JUNIPER SAUNA CO.

LANDSCAPE  
PLAN

LANDSCAPE  
NOTES &  
DETAILS

RE: DSRFY2025 - 0010  
Response to DR Comments and Resubmittal narrative

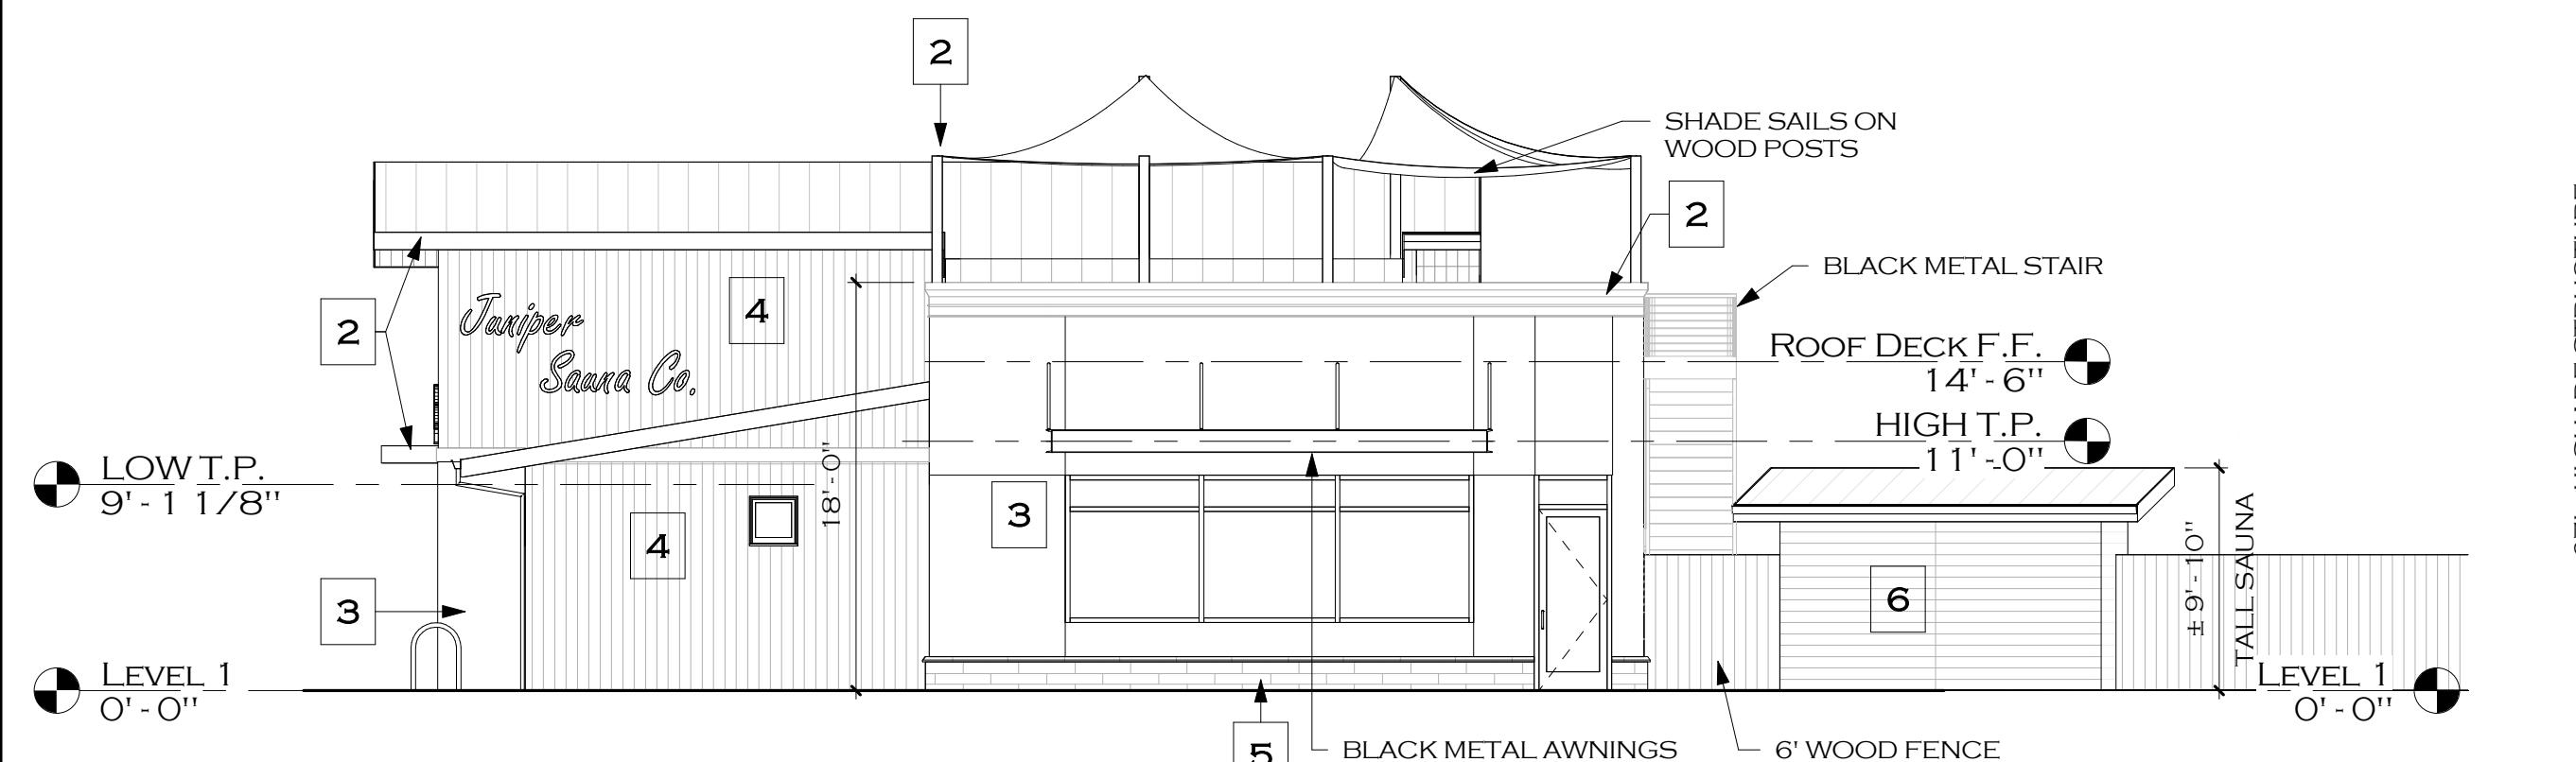
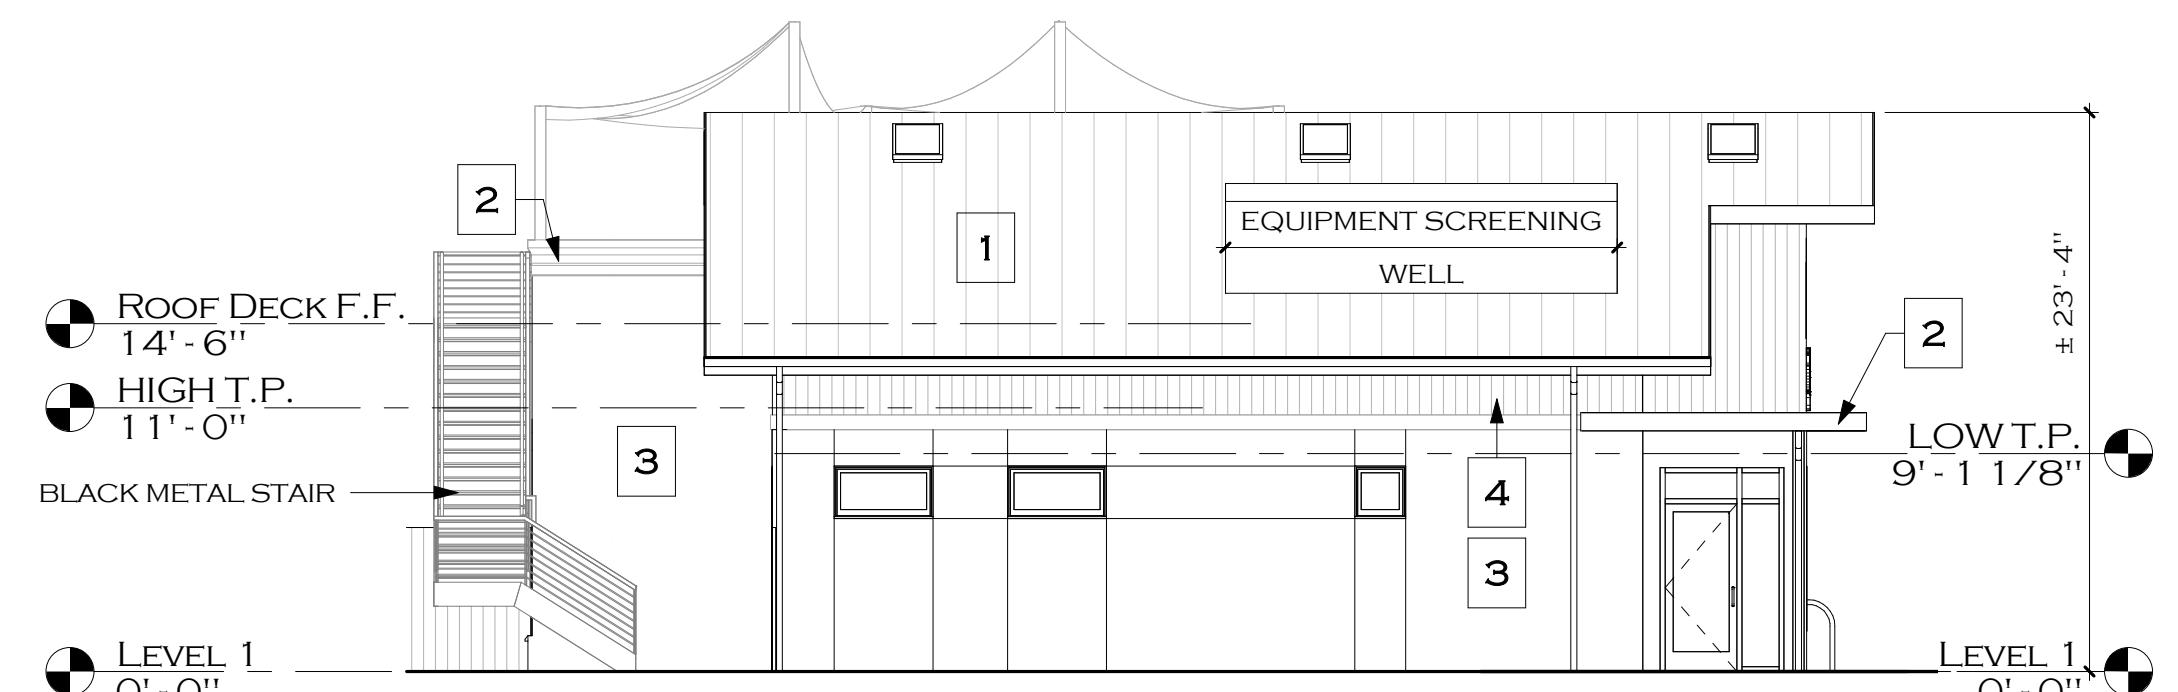
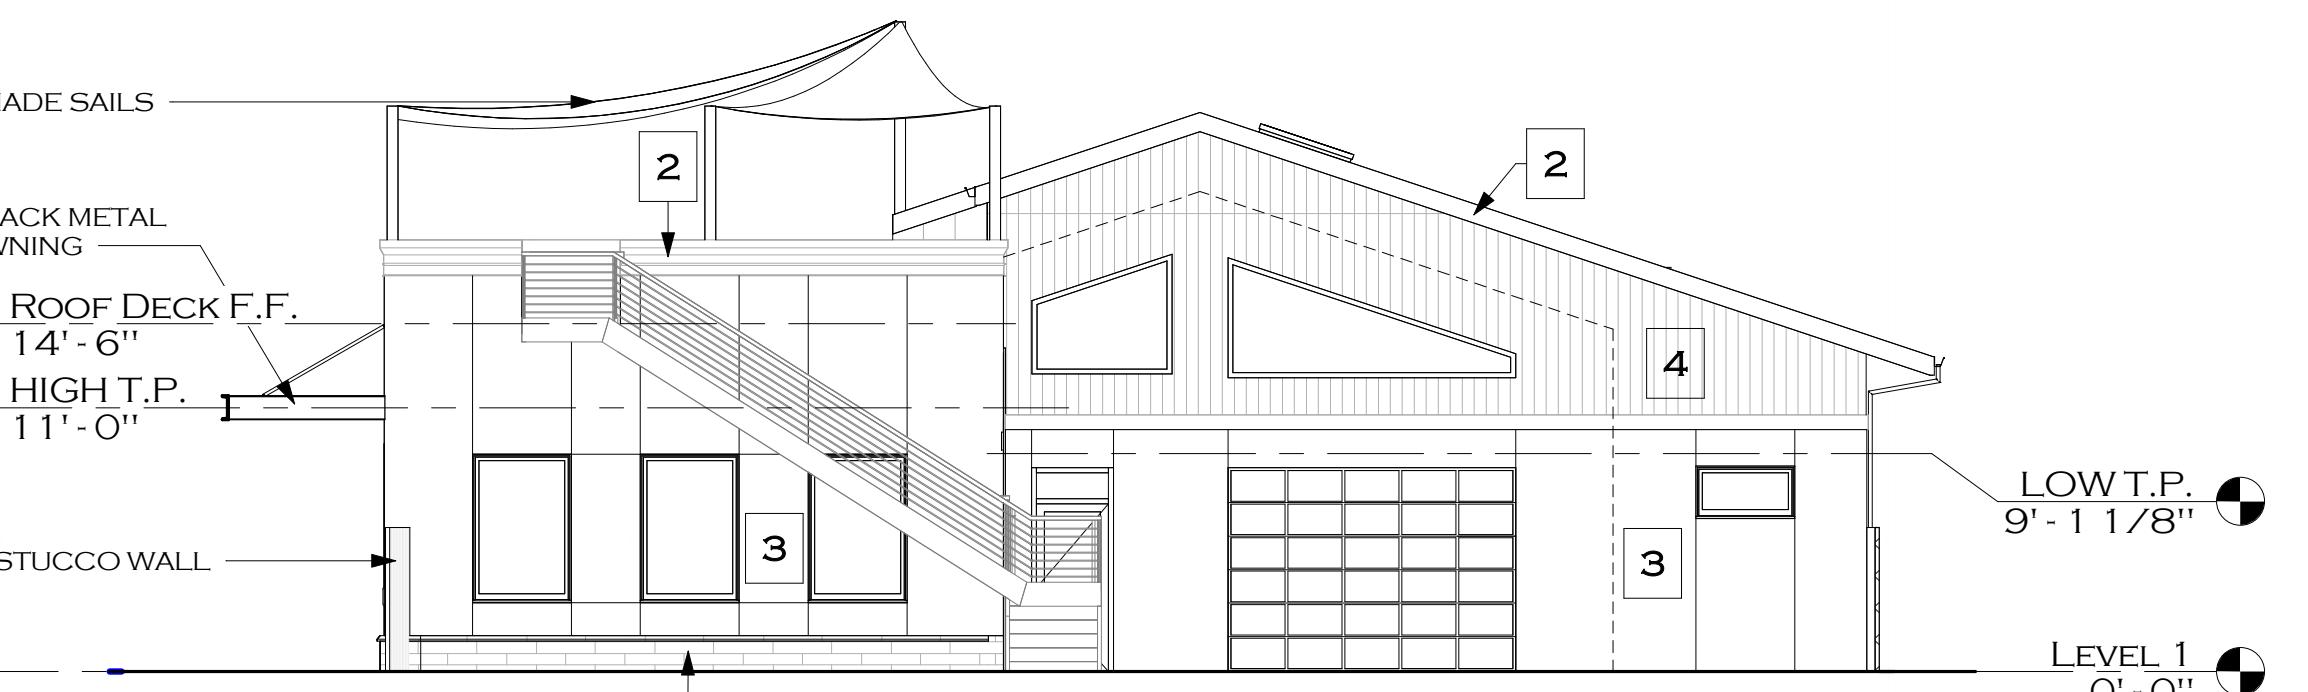
First Floor Facades: Calculations have been added to the exterior elevations and they exceed the min. requirement of 15% for the Health Club use.

WALL AREA: 720.20 S.F.  
OPENINGS: 154.45 S.F. PERCENTAGE OF FACADE OPENINGS: 21.4%

WALL AREA: 577.28 S.F. OPENINGS: 130.51 S.F. PERCENTAGE OF FACADE OPENINGS: 22.6%

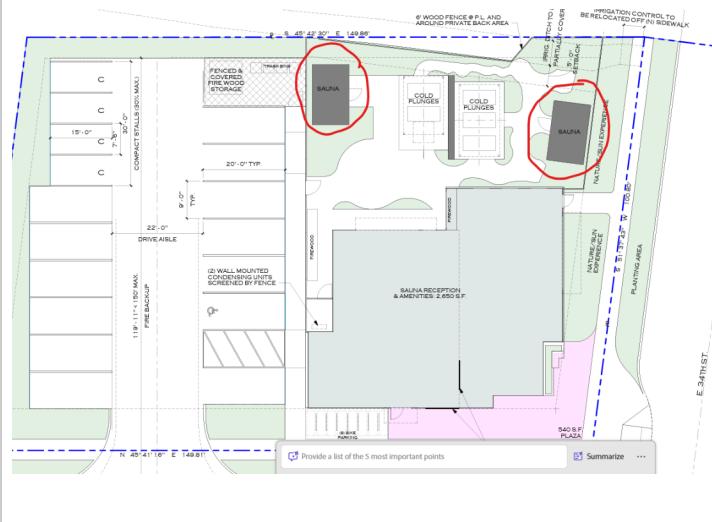
Upper right corner (SE) of the site plan is where the ditch is located and we are planning on partially undergrounding it.

Thanks for the plan Daphne, FALWUA is in support of this plan as proposed. Let us know if you need anything from us as you move forward.
